**Subject: Cab-to-Chassis Redundant Ground
Strap Installation - FTL Service Bulletin 54-
318.**

**Models Affected: On New Cascadia vehicles Penske/Black Horse
units built prior to May 23, 2019.**

Subject: Cab-to-Chassis Redundant Ground Strap Installation - FTL Service Bulletin 54-318.

Fig. 2, Cleaning the Area Around the Bracket

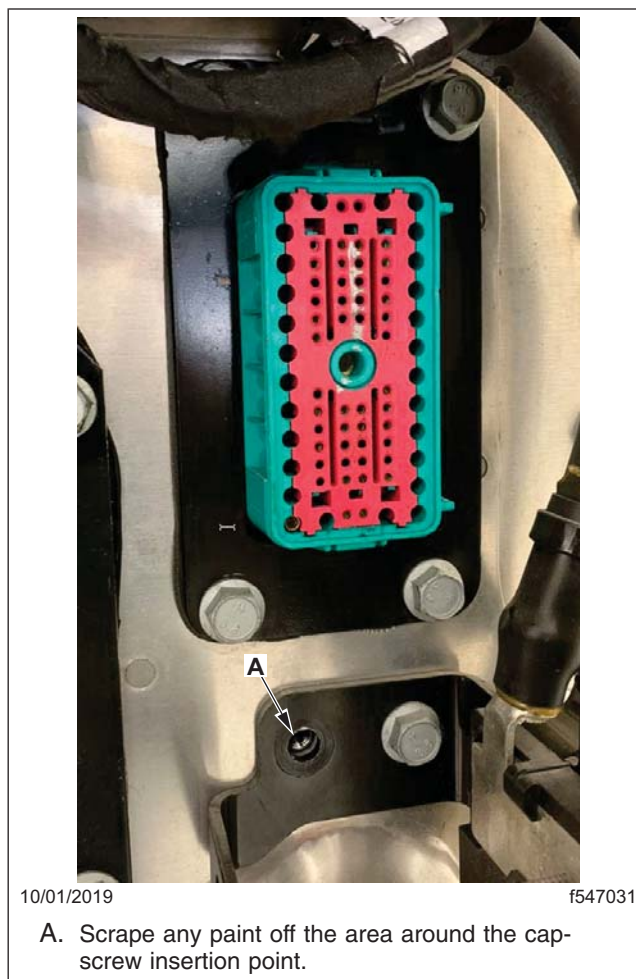
4. Scrape a small amount of paint off of the bracket so that the face of the capscrew will have metal-to-metal contact. See [Fig. 2](#). This ensures that the ground strap and the MGJB have continuity with the frontwall when the nut is installed.

Fig. 3, Frame-Mounted Stud for GNDP

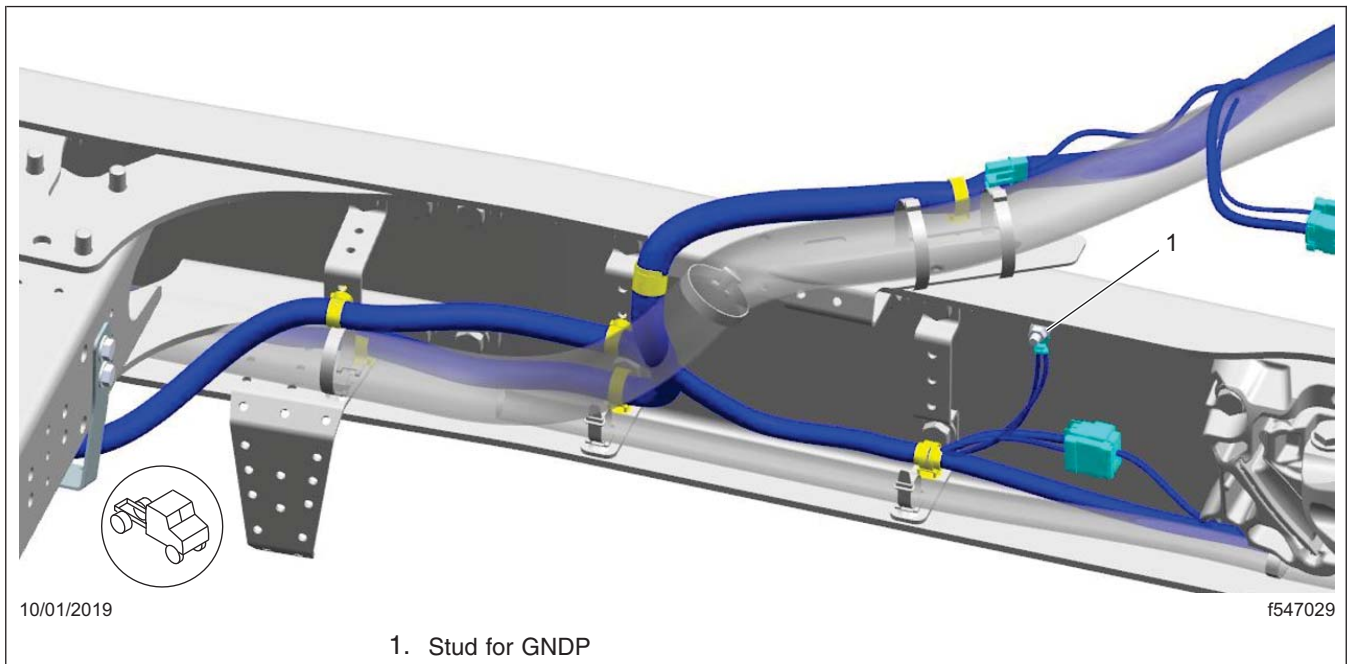
NOTE: Both sleeper cabs and day cabs with an under-cab battery box mounting have the same frame-mounted power ground (GNDP) stud. See [Fig. 3](#).

Fig. 4, Location for the Ground Strap

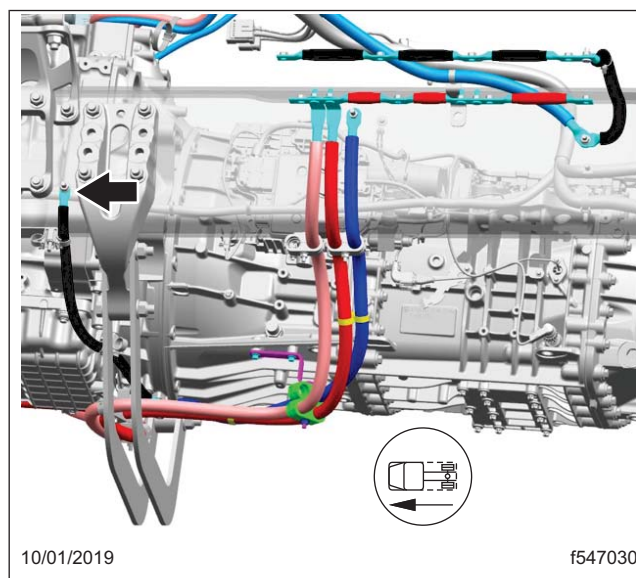
5. Determine the location for the redundant ground strap.
 - 5.1 Check to see if the battery box is mounted between the frame rail. On vehicles that have a battery box mounted between the frame rail, there is a ground strap running from the flywheel housing to the left-hand side frame rail. This is the most accessible frame rail stud for mounting the redundant ground strap. See [Fig. 4](#).
 - 5.2 If the vehicle has an under-cab battery box, check for a ground stud on the left side outer frame rail. There will be a difference between applications with frame rail battery box mounting and an under-cab battery box mounting, depending on the 282 data code for the build. Vehicles with an under-cab battery box mounting will not have the ground mounting stud, as shown in [Fig. 5](#). In this case, the best location is the GNDP stud shown in [Fig. 4](#).

6. Once the stud for the redundant ground strap is determined, remove the nut from the stud. Clean off the anti-corrosion spray as necessary to ensure clean contact with the face of the existing cable. Install the ring eye of the new ground cable on the stud, and install the nut. Tighten the nut to 26 lbf·ft (35 N·m).
